# **Minimum Operational Performance Standards for Geosynchronous Orbit Aeronautical Mobile Satellite Services (AMSS) Avionics**

## **Change 4**

RTCA DO-210D Change 4  
March 24, 2015

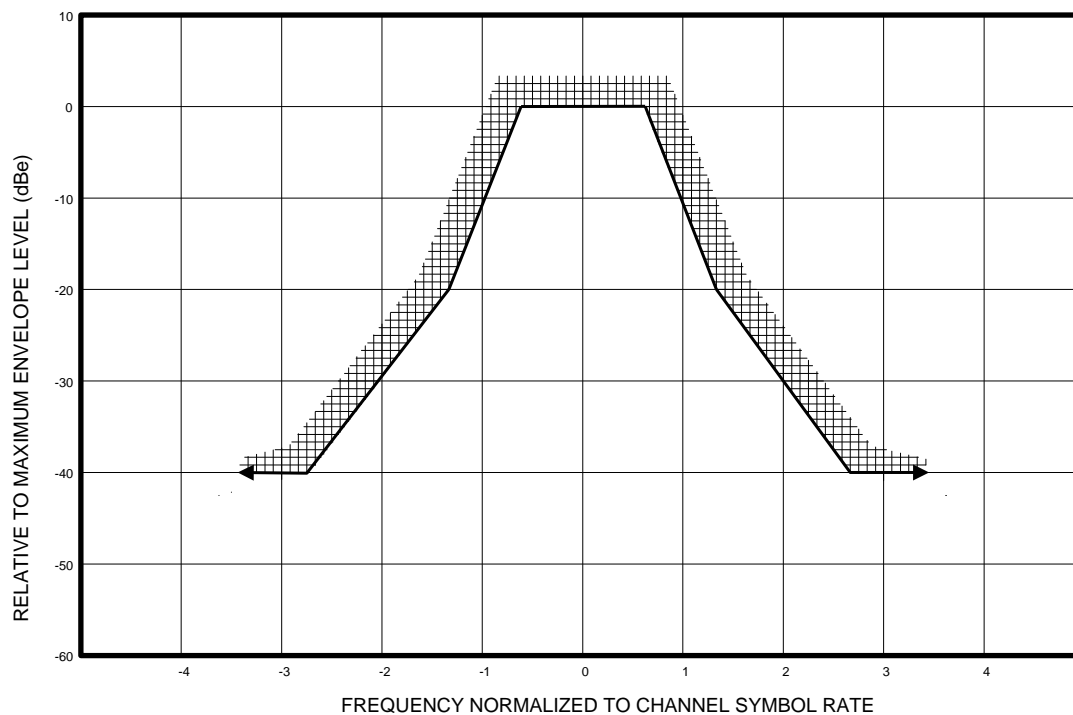
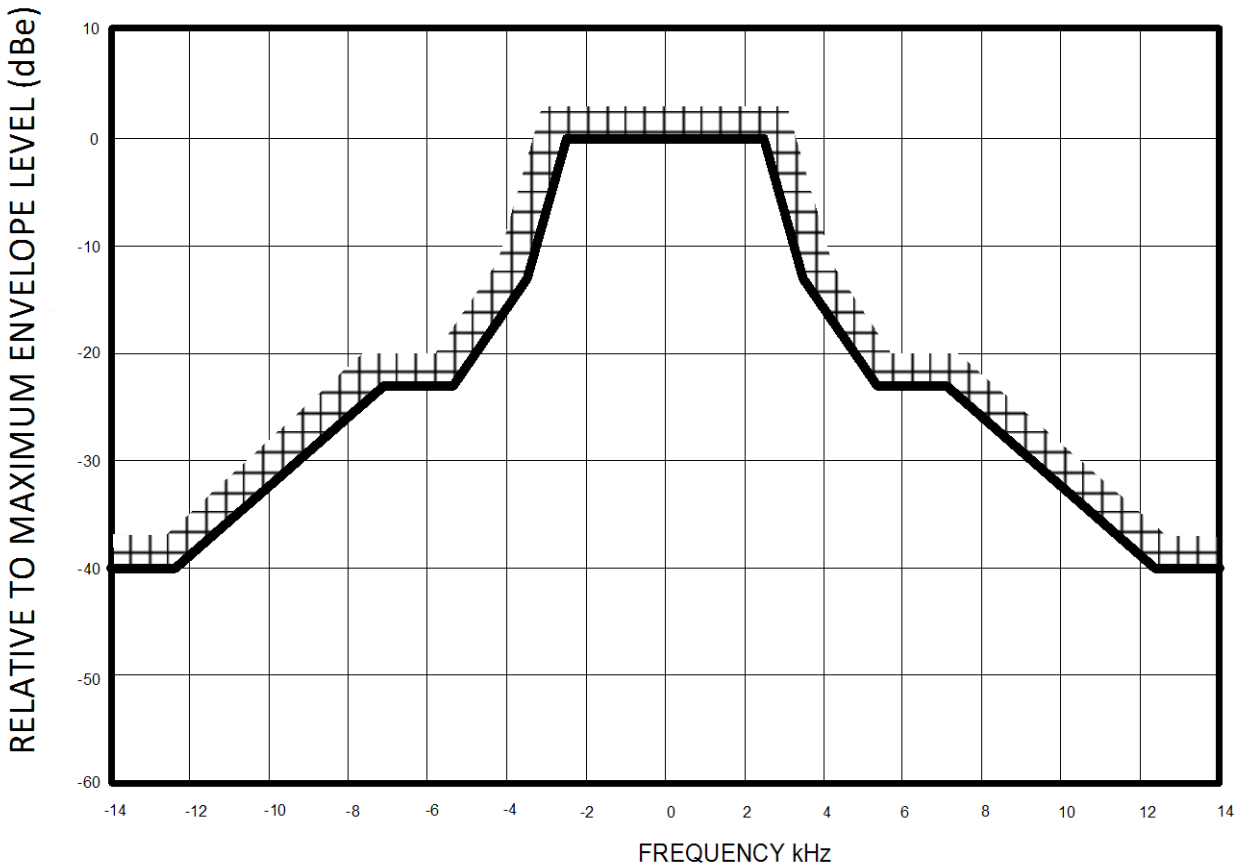
7. Replace DO-210D 2.2.4.2.16 in its entirety by the following text:

“While transmitting a single modulated signal at the rated output power of the transmitter, the transmitted signal power spectrum levels at the transmitter output terminal shall be no greater than the values shown in Figure 2-0A (8.4kbps channel) and Figure 2-0 (all other channels).

The breakpoints in Figure 2-0 are:

Frequency Offset	Spectrum Level
$\pm 0.75 \times \text{SR}$	0 dBe
$\pm 1.40 \times \text{SR}$	- 20 dBe
$\pm 2.80 \times \text{SR}$	- 40 dBe
greater of $\pm 4 \times \text{SR}$ and $\pm 35 \text{ kHz}$	- 40 dBe

The breakpoints in Figure 2-0A are:

Frequency Offset	Spectrum Level
$\pm 2.6 \text{ kHz}$	0 dBe
$\pm 3.5 \text{ kHz}$	- 13 dBe
$\pm 5.3 \text{ kHz}$	- 23 dBe
$\pm 7.1 \text{ kHz}$	- 23 dBe
$\pm 12.3 \text{ kHz}$	- 40 dBe
$\pm 35 \text{ kHz}$	- 40 dBe

For frequencies within  $\pm 35 \text{ kHz}$  or  $4 \times \text{SR}$  of the designated channel, the measurement resolution bandwidth should be approximately  $0.1 \times \text{SR}$ . The envelope level listed in the table is the relative amplitude as measured in the resolution bandwidth as a function of the frequency offset from the carrier frequency. The maximum level, which is the reference for the dBe criteria, will occur at the carrier frequency.

In the frequency band from  $\pm 35 \text{ kHz}$  or  $4 \times \text{SR}$  until  $\pm 100 \text{ kHz}$  from the designated channel, the emissions level shall be less than  $-55 \text{ dBc/4 kHz}$ . Compliance with this requirement shall be measured using the techniques of 2.2.4.2.5.1 and 2.2.4.2.5.2.

Beyond  $\pm 100 \text{ kHz}$  from the designated channel, the emissions shall meet the requirements of 2.2.4.2.5.1 and 2.2.4.2.5.2.”
